Subject: Studs for cylinder heads

Affected engine models:

Abb. 1
Fig. 1

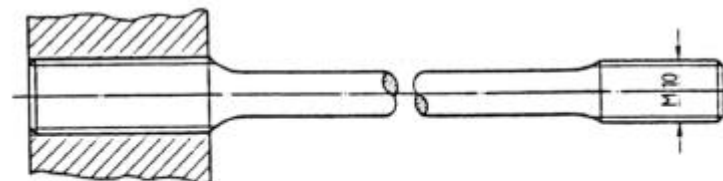
On abovementioned L 2000 engine models broken cylinder head studs were occasionally reported. These are traced back to excessive fatigue loads due to high-speed detonation.

Studs, accompanied with threaded inserts according to Fig. 1 are replaced by those according to Fig. 2 by design, the new type studs have a superior fatigue strength. L 1700 series engines are also equipped with the new style cylinder head studs.

The new type cylinder head studs cannot be retrofitted on older engines since the crankcase might be damaged when removing the threaded inserts. The new style studs require a different torque (see service literature).
